RE: **Lot 6 Block 9 Unit 18 SAD 228
6220 Keyenta Pl. NW
Volcano Cliffs Subdivision
Grading and Drainage Plan
Engineers Stamp Date 2/5/2021 (E10D098)**

Based upon the information provided in your submittal received 3/3/2021, this plan is approved for Grading Permit.

DRAINAGE AND TRANSPORTATION INFORMATION SHEET (REV 6/2018)

ENGINEER'S SEAL	LOT 6 BCK 9 U 5 VC 6220 KEYENTA PLACE NW	DRAWN BY DEM
DAVID SOULE REGISTERED PROFESSIONAL ENGINEER 14522	GRADING AND DRAINAGE PLAN	DATE 2-4-21
2/5/21	Rio Grande Engineering	LOT 6 BCK 9 U 5 VC DWG
DAVID SOULE P.E. #14522		SHEET # C1
		JOB #

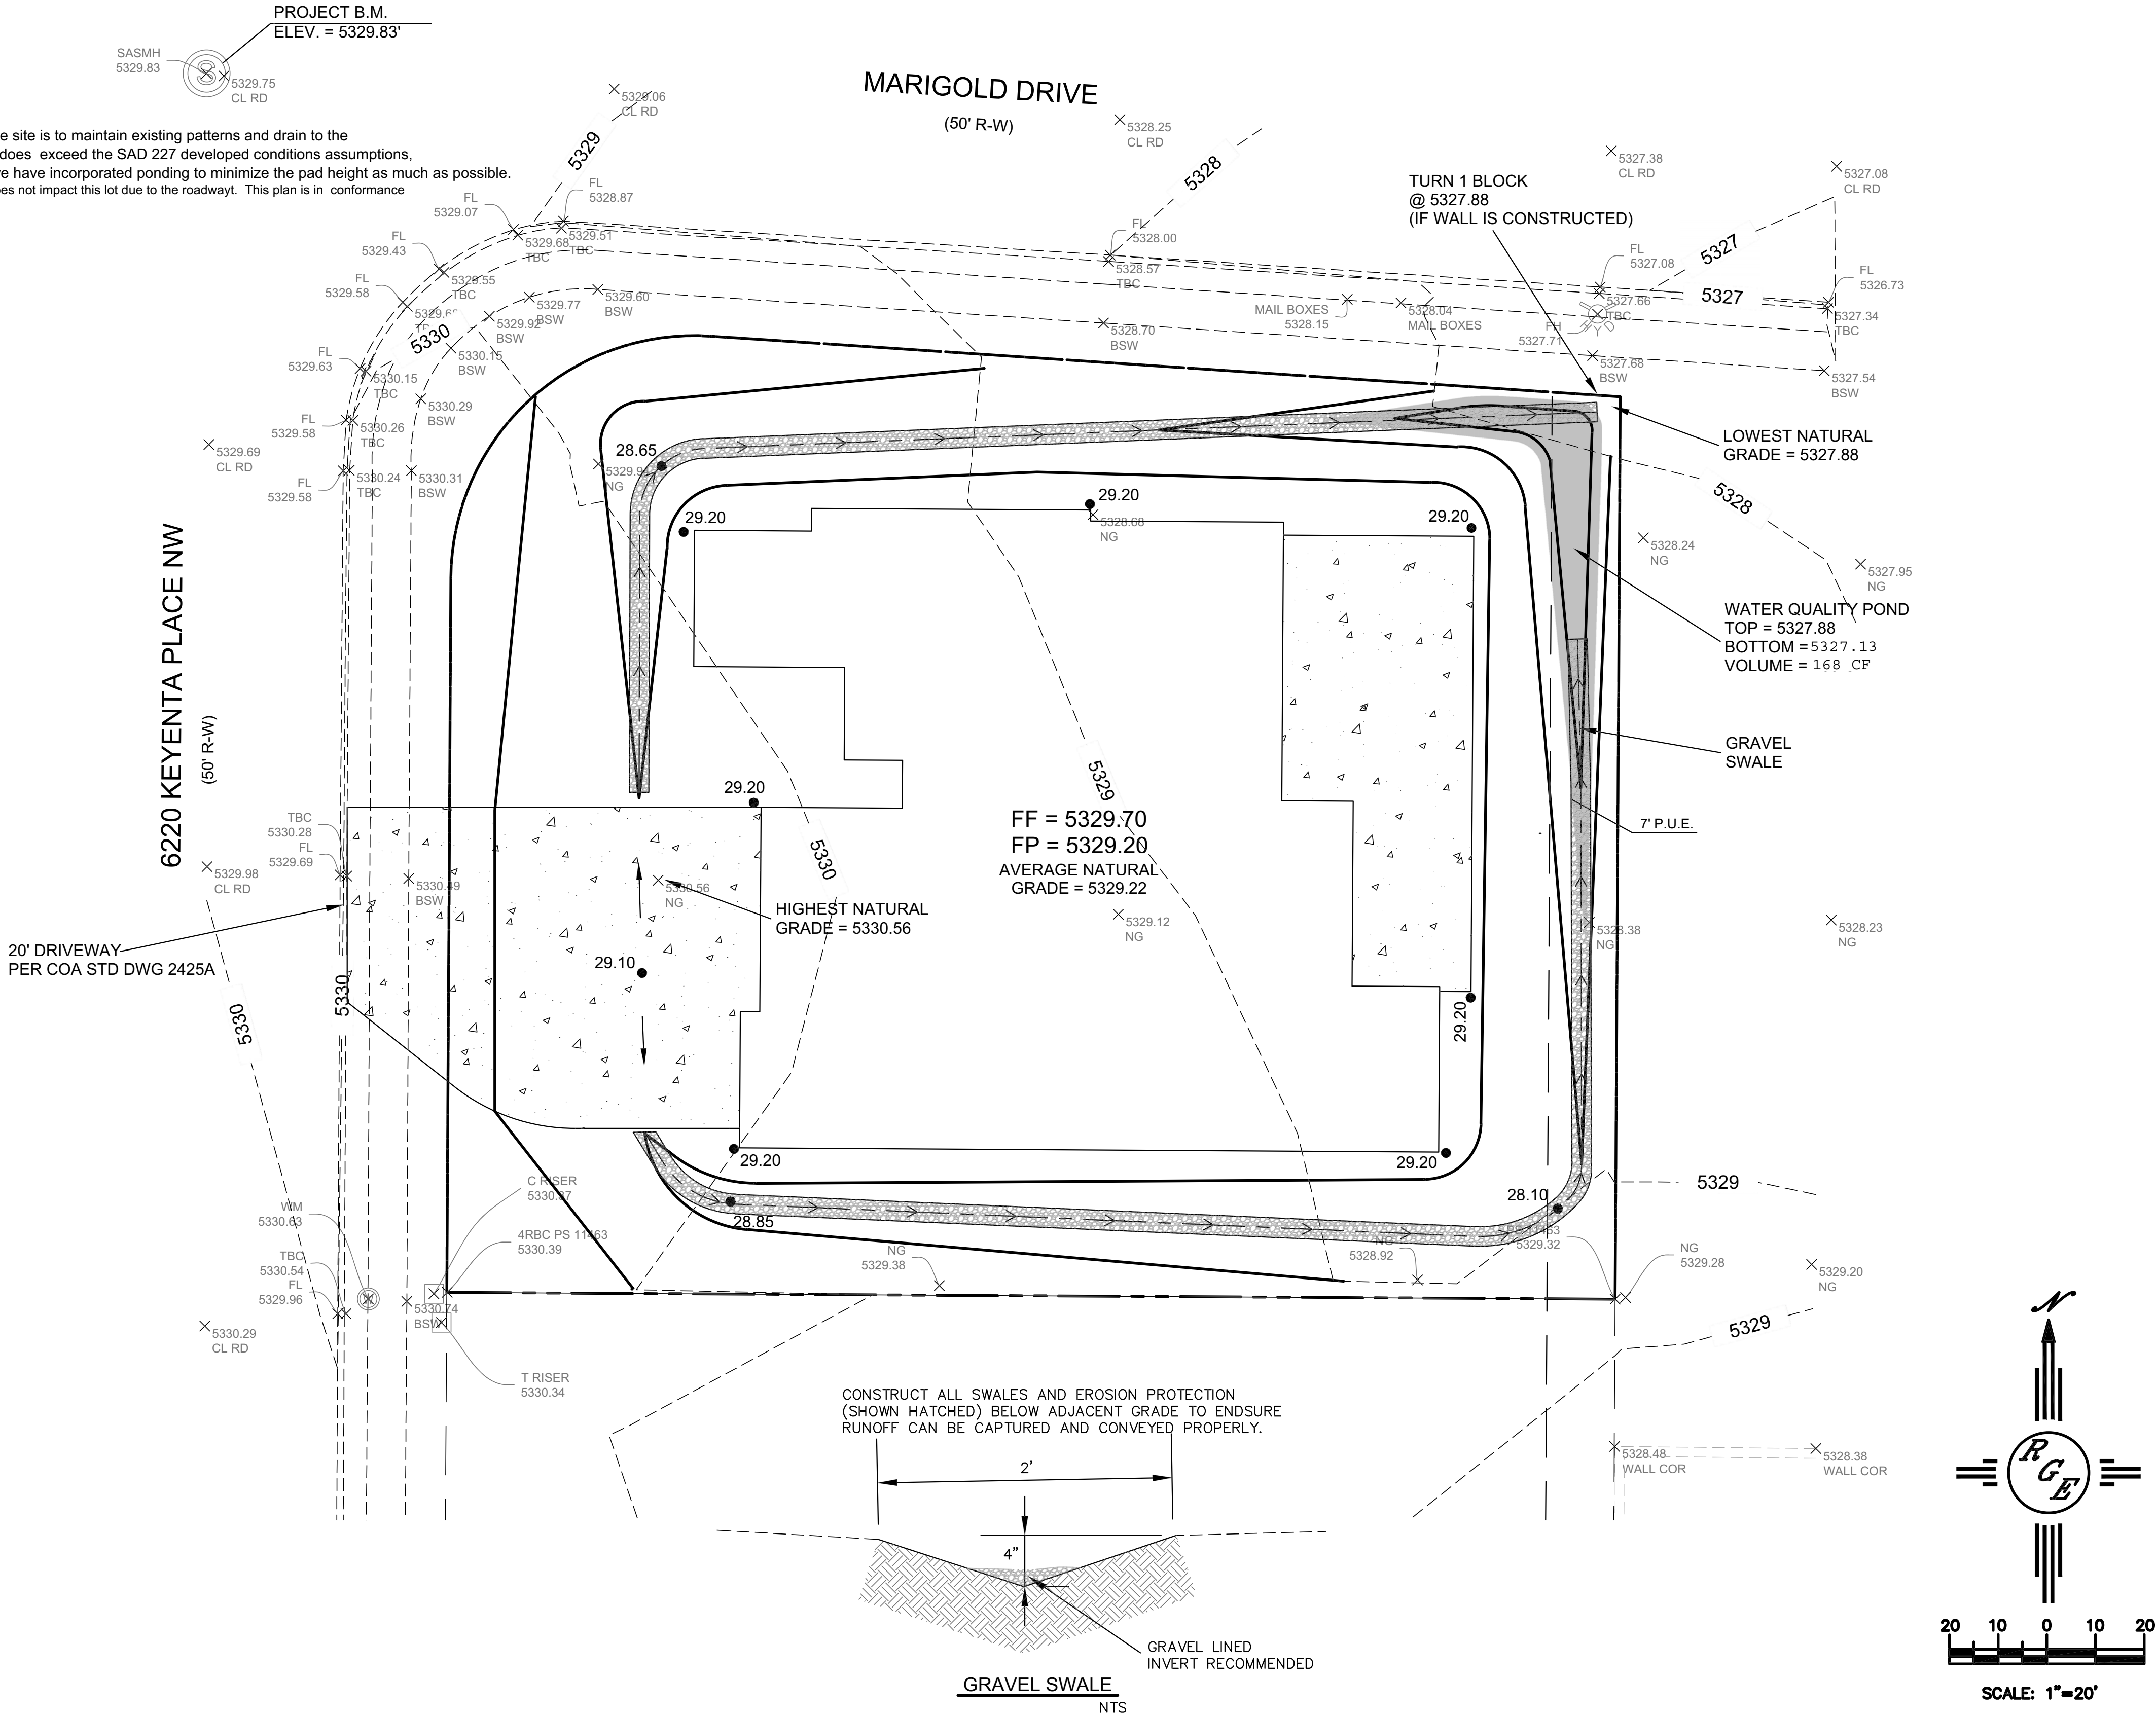
Prior to Building permit approval a Pad Certification will be required, provided by the Engineer or a registered Land Surveyor.

Advise the owner contractor not to use dirt as a ramp to climb the curb, use lumber or crusher fines for this purpose.

Reiterate to the Owner/Contractor that a separate permit for a garden/retaining wall must be obtained with the approved G&D plan and Pad Certification. Also, if a swimming pool is to be placed the grading and drainage plan will change and will need to be resubmitted.

Prior to Certificate of Occupancy release, Engineer Certification per the DPM checklist is required.
